EG21 and EGS21 Series Electric Gage and Swichgage® Installation for Pressure, Temperature, Fuel Level, Voltmeter and Ammeter

IMPORTANT NOTICE FOR ALL EG21 ELECTRIC GAGES AND EGS21 ELECTRIC SWICHGAGES FOR 24VDC AND 32VDC APPLICATIONS

Wire/Connector Assembly

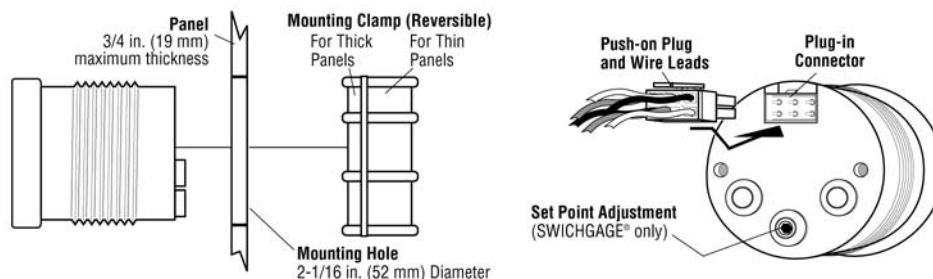
A change in the dial illumination circuit has made it necessary to change the external wiring harness. If you use the incorrect wiring harness, irreparable damage will occur to the gage mechanism.

The table below lists correct wire harness assemblies for units by manufacturing date. For date code R1 (January 1996) or earlier (Q12, Q11, etc.) the wire harness can be identified by P/N and by BLACK shrink tubing on the YELLOW wire. For date code R1 (February 1996) and later (R3, R4, etc.) the wire harness can be identified by P/N and by RED shrink tubing on the YELLOW wire.

Date Code R1 or Earlier	Date Code R2 or Later
05004546	05006166
05004547	05006167
05004548	05006168
05004549	05006169
05004550	05006170
05004551	05006171
05004552	05006172

If dial illumination is NOT required, either wire harness can be used on any date code, if the YELLOW wire is **NOT** connected.
